Location of Construction: 112 Shepherd Lane		Owner: Arthur Burton		Phone:	
Owner Address:		Leasee/Buyer's Name:		Phone:	
Contractor Name: Dave Kenney Builders, Inc.		Address: 9 Wildridge Rd Standish, ME		Phone: 04084 642-2906	
Past Use: 1-fam		Proposed Use: Same w/deck		COST OF WORK: \$ 2,100.00	
				PERMIT FEE: \$ 30.00	
				FIRE DEPT. <input type="checkbox"/> Approved <input type="checkbox"/> Denied	
				INSPECTION: Use Group: B3 Type: B BOC # 43	
Proposed Project Description: Construct Deck (12' x 16')				Signature: _____ Date: _____

BUILDING PERMIT REPORT

DATE: 20/MAY/96 ADDRESS: 112 Shepherd Lane
 REASON FOR PERMIT: To Construct Deck
 BUILDING OWNER: Burton
 CONTRACTOR: Dave Kenney Bldg. Inc APPROVED: ✓ 11 13 16
 PERMIT APPLICANT: _____ DENIED: _____

please use space below for drawing of deck with measurements.

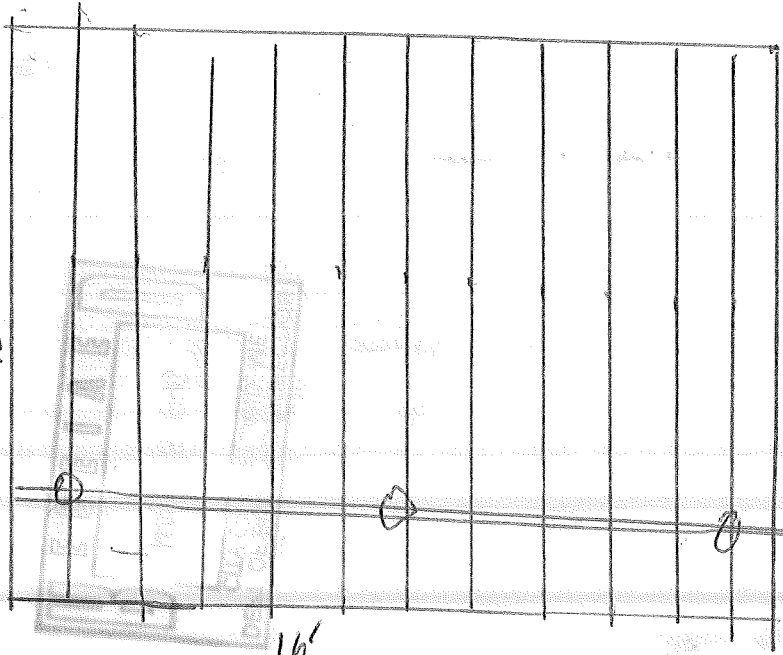
5-20-96 - 3 8" ϕ sonotubes in prior to permit approval /

5-23-96 - No framing yet, left tag to continue / 1

6-26-96 Deck Framing OK pp. / stairs over 8 risers / need guard rails on car side?
